SUBJECT: CASE NO. 2017-003559ENV -- 3700 CALIFORNIA DEIR – COMMENTS

I submit to you my comments on the proposed 3700 California Draft Environmental Impact Report (DEIR).

**Figure 2-13**  
**Block A Access, Circulation, and Ground-Floor Parking Plan**

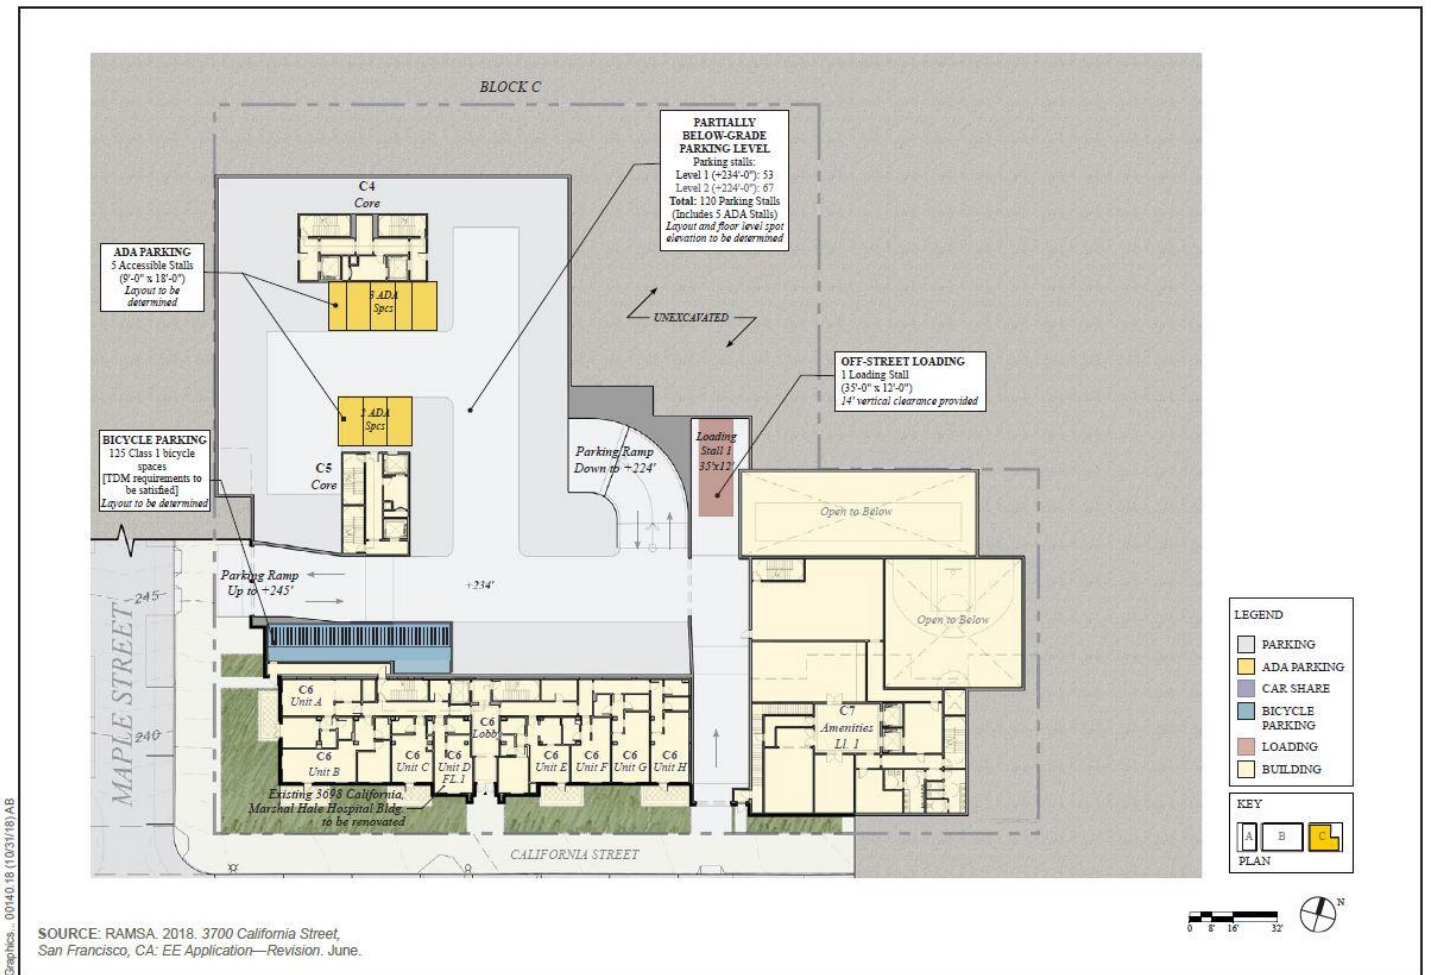
Pages 2-28, 2-30 & 2-31, Figures 2-13, 2-14, & 2-15, “Access, Circulation and Ground-Floor Parking Plan” (each for Blocks A, B & C): While this is about parking, this has an impact on building height. With building height appearing to loom over the California Parker view corridor from the south, perhaps parking stackers could lessen the higher portion of the building heights of Blocks B & C as one looks from the south towards the north (from California to Sacramento). Building C on Sacramento when seen from Parker & California appears to be very tall due to the huge slope from California to Sacramento. Suggestion to decrease the individual subterranean spaces to parking stackers and shift some livable space lower. Can you provide how much of the taller buildings on Blocks B & C could be lessened if stackers were used? This would lessen the impact to those looking uphill from California to Sacramento and from the view westward along California looking at the taller portions of the buildings for Blocks B & C.

**Figure 2-10**  
**View of Blocks B and C from**  
**California Street Looking West**

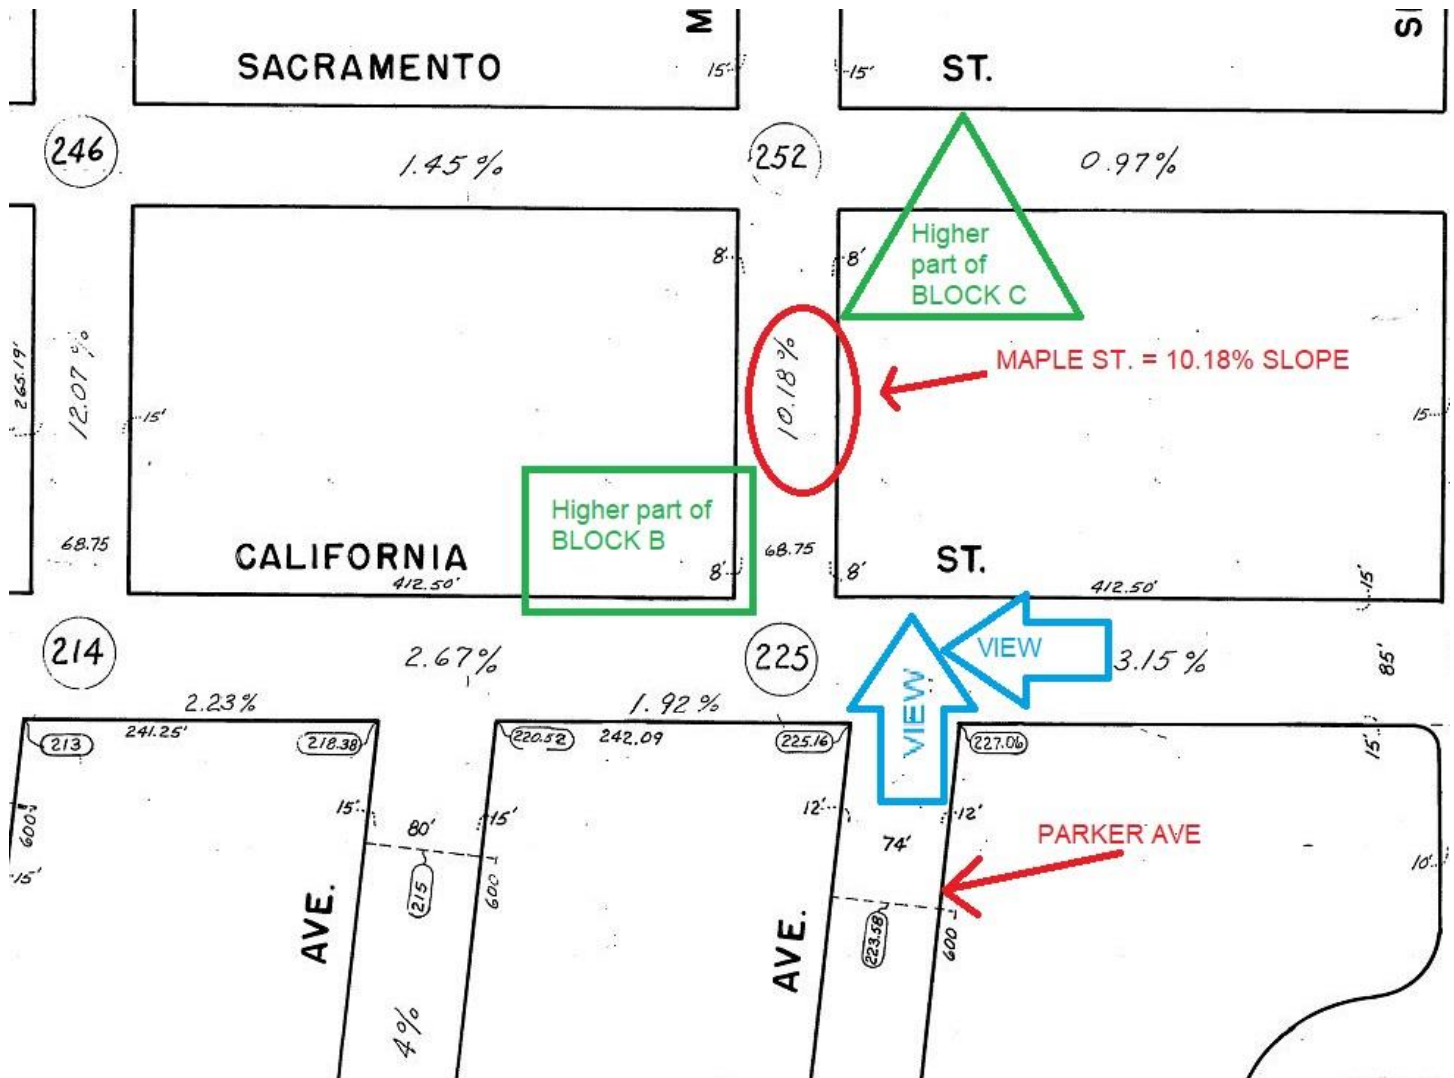
Here are the views Page 2-20 & 2-21, Figures 2-9 & 2-10 provided in the EIR for Buildings B & C. The 7-8-story higher portions of Building B (SE corner) & Building C (overall at 96 ft. + rooftop appurtenances) is a much more looming impact on the pedestrian on the sidewalk in this area of mostly 40-foot tall residential buildings in the JPIA area. Having 1 story less on the SE portion of Building B & 1 less story on Building C would create a more harmonious and smoother transition to the lower heights of JPIA buildings. The camera angle in the pictures in the DEIR do not show from a nearby pedestrian's perspective but from farther away and even that is not such a smooth transition.

Look at Block B building in this [Figure 2-10](#). See how the 7<sup>th</sup> story is not a smooth transition looking from the historic Marshall Hale Building (where the trees on the right are). The brick building at 2 Parker is 40 feet tall. Count 4 floor up on Block B – the new proposal is 3 stories above it.

The view going westbound (towards the left in the diagram) along California of the tallest part of Block B is much more impactful as a pedestrian closer to the corner than is depicted in the image in [Figure 2-10](#).

**Figure 4.2-2  
Existing Site Plan and Access Routes**

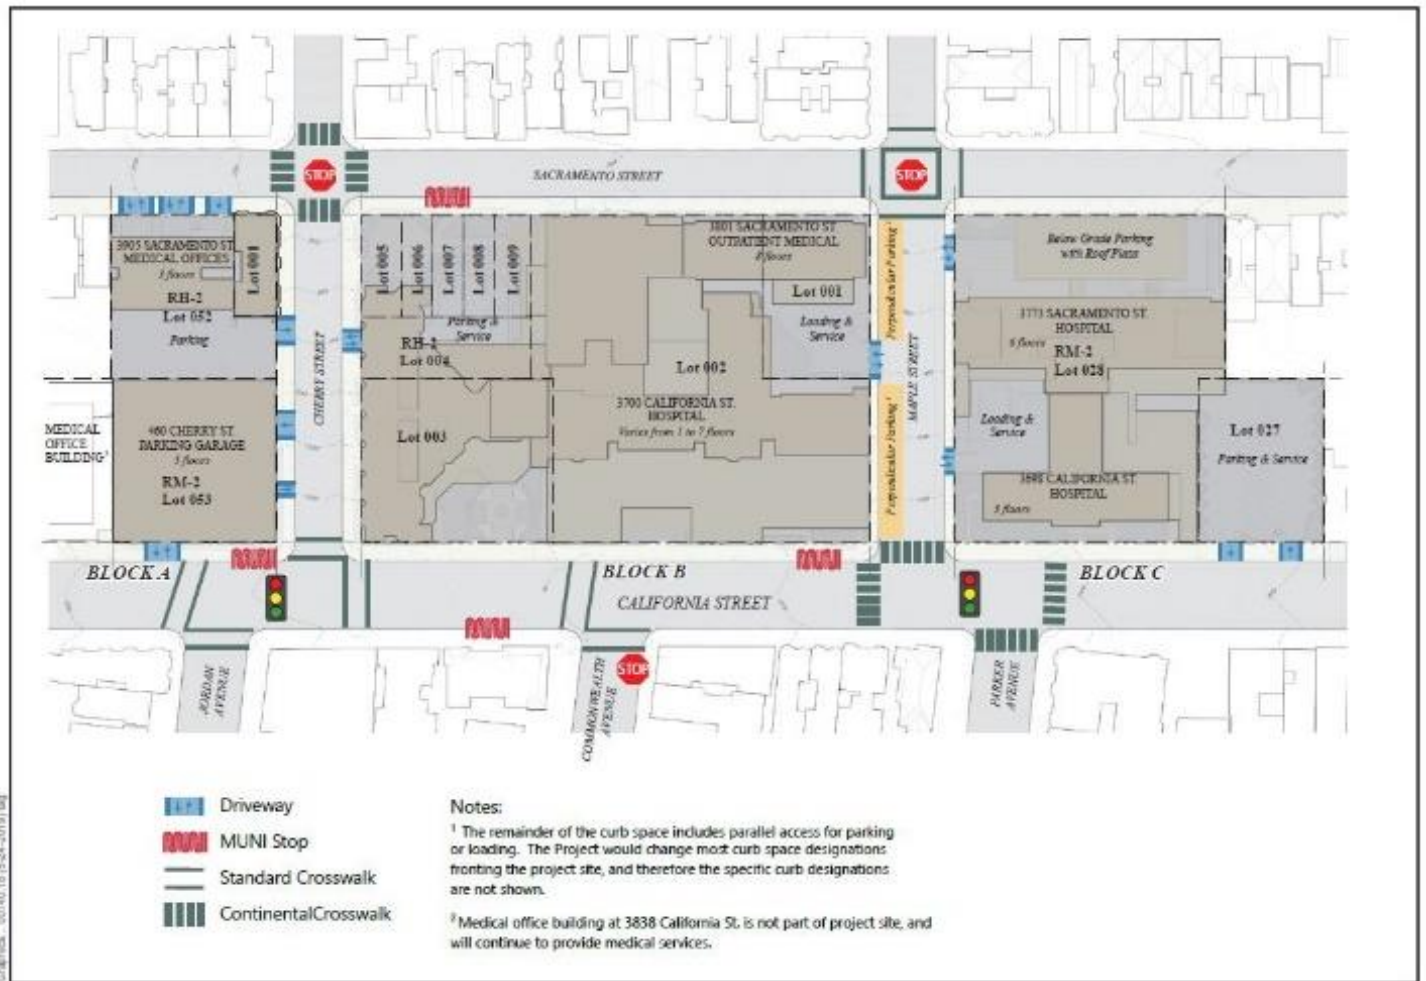
Page 4.2-3, Figure 4.2-2, "Existing Site Plan and Access Routes": There were 4 existing CPMC driveways For the Block A portion. Vehicles could use Cherry, Sacramento and California for relief from all the traffic. Cherry St. had 4 driveways for Block A and Block B location hospital use visitors and employees to park their vehicles. There were 3 driveways on Maple for vehicles but 2 of the driveways were for \*only\* LOADING vehicle purposes. See below Page 4.2-37 for comments that relate to Figure 4.2-2 (hospital use driveways that were there) and Figure 4.2-5 (proposed residential driveways).

**Figure 4.2-5**  
**Multi-Family Parking Garage and Onsite Loading Access**

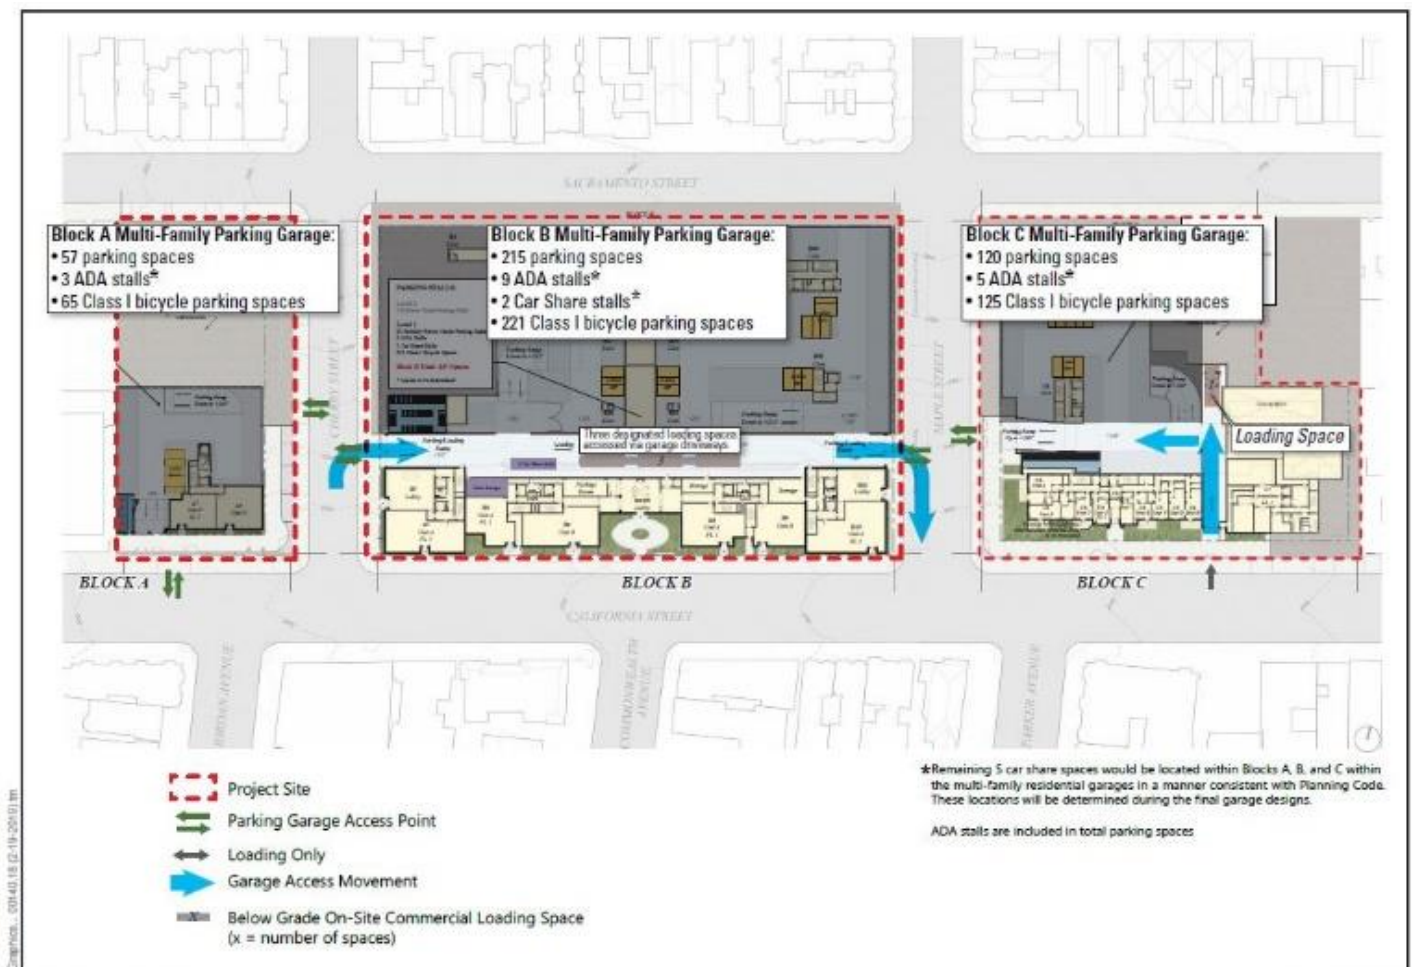
Page 4.2-37, "Figure 2.4-5, "Multi-Family Parking Garage and Onsite Loading Access": As you can see, the Block B building is going to have 147 residential units the highest number of parking spaces at 223. Block A will have 67 parking spaces for 43 units. Block C will have 126 parking spaces with 83 units. Seems like a lot of vehicles considering the mantra at City Hall that the younger folks do not drive. Elderly people will eventually not drive. What segment of the population was being targeted to build units for Block B with the number of parking spaces proposed?

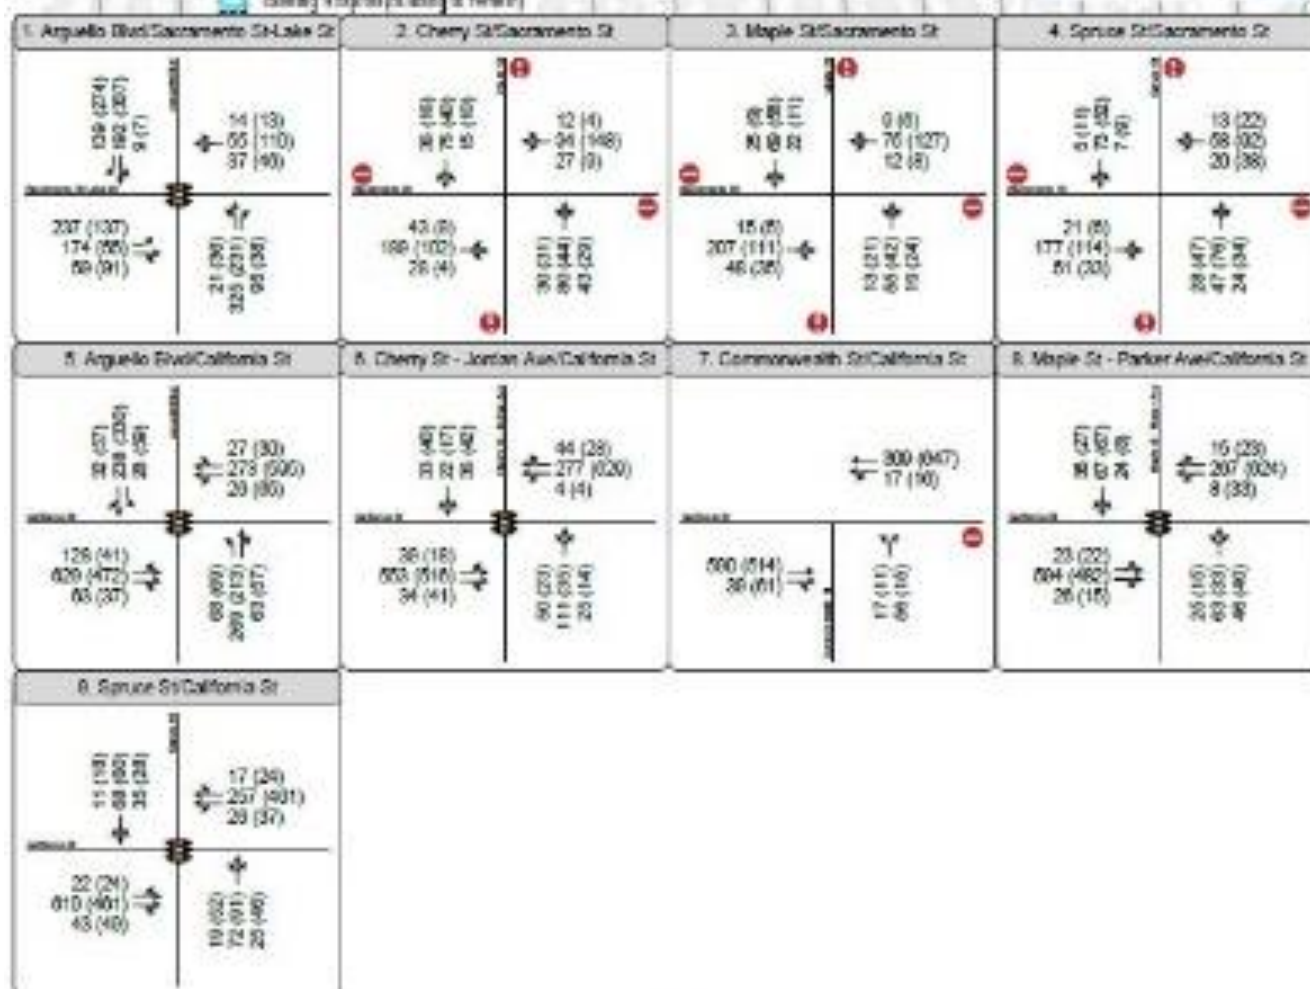
Page 4.2-48, Table 4.2-8, “Proposed Project Driveway Volumes”: See earlier comments above. These “Existing ‘Peak Hour’ Traffic Volumes” are from the Appendix on Page 15, Figure E-1:

The hospital use had 67(67) going to 85(68) which is a total of 134 vs. 153, a **~14% increase** (19 vehicles increase) of a less intense residential use. Also, 63(33) is going to 60(51) which is a total of 96 vs. 111, a **~16% increase** (15 vehicles increase). This is an increase only during the peak hour and what is not shown are the total counts daily on each street separately. Please provide the new data for each separate street block south of California 000-blocks of Palm, Jordan, Commonwealth & Parker; and 100-blocks of Palm, Jordan, Commonwealth & Parker during a time when the full University of San Francisco student body is in active session because they park on the JPIA streets from my observations over the decades. This is also not taken into account in the DEIR.

Figure 4.2-8  
Peak Hour Traffic Volumes  
Net Change in Project Trips

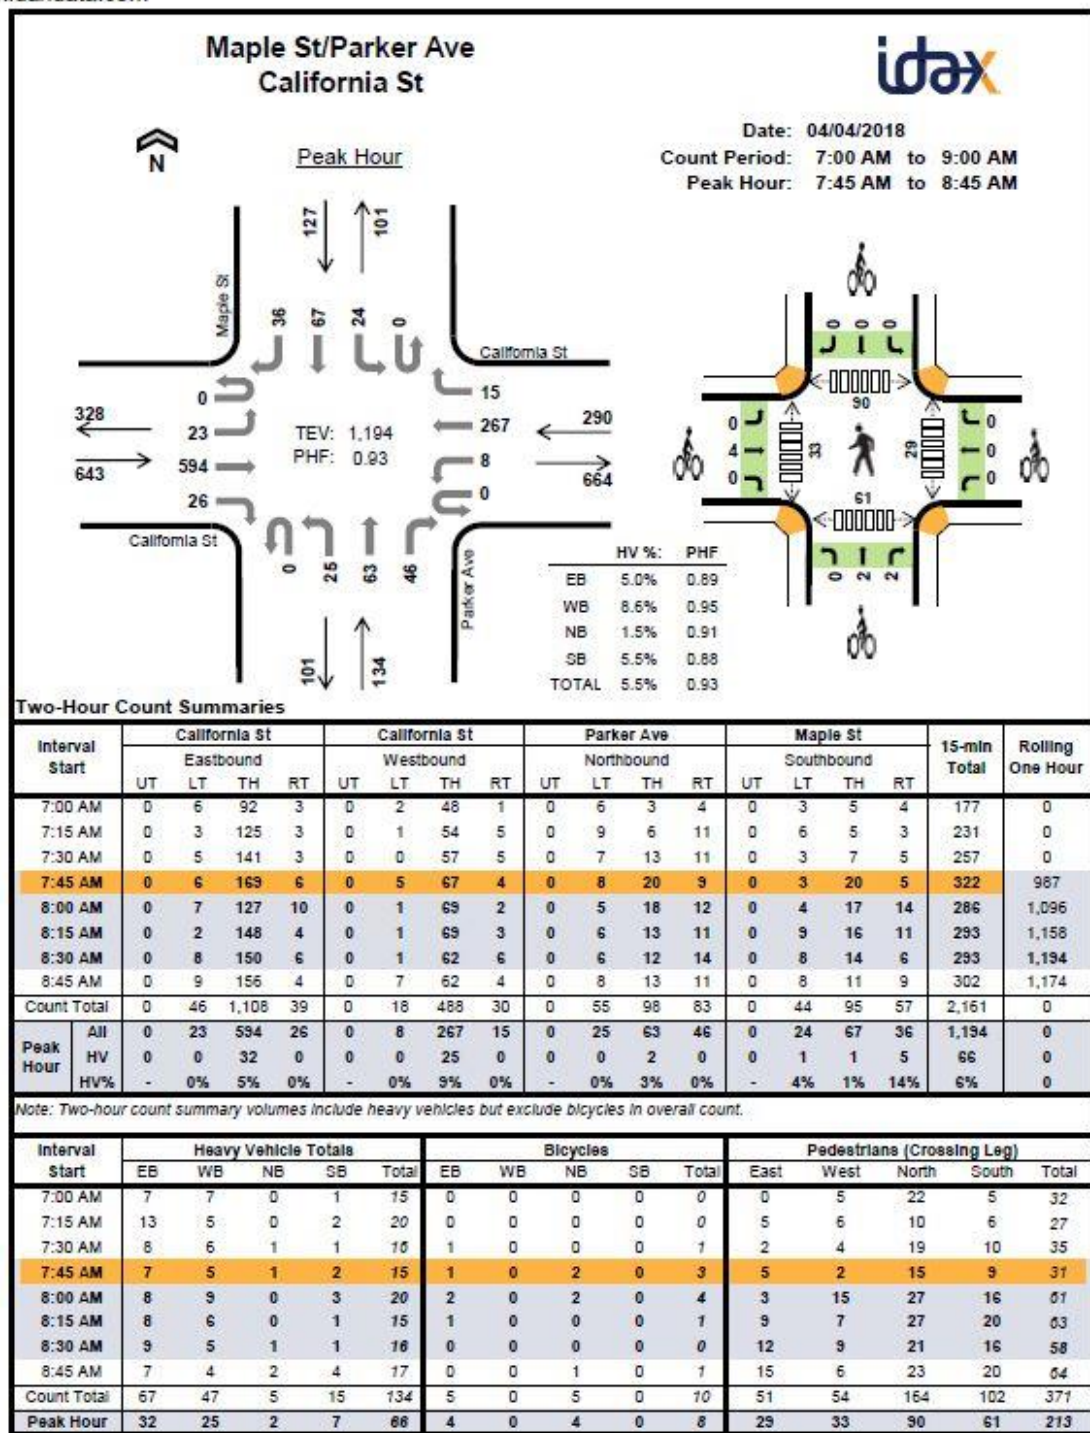
Page 4.2-49, Figure 4.2-8, “Peak Hour Traffic Volumes, Net Change in Project Trips” (aka “Appendix F, Page 48”):

This below Figure 4.2-8 shows like there is very little traffic volume but one must look at Figure E-2 above found in the Appendix to see that there will be a lot of traffic at the intersections and turning south onto JPIA streets. Use of “trip credits” from the old CPMC Project as if that still existed which has been vacant for a while now rather than exact numbers for the PROPOSED scenario once the residential project is built is like using a bad driving scenario to justify the number of vehicles on-site without, I believe, enough driveways for the vehicles to eek out to other areas north and south where there are NO DRIVEWAYS. How does one account for the psychology or the verified potential employment locations or habits of the NEW RESIDENTS to determine which direction they will drive to conclude that the impacts to the neighborhood streets downstream (south of the site) is NI or LTS? Please explain.

This Figure 4.2-8 shows “Peak Hour” Traffic Volumes as “Net Change” for the counts for Maple St/Parker Ave – California St. These are counts after the hospital has moved out and still there are 322 vehicles at this location.

How many vehicles are expected down each of the streets south of California without “netting out”? Please provide.

How many **vehicles TOTAL** during the hours of 7AM to 7PM daily for each of the above streets?
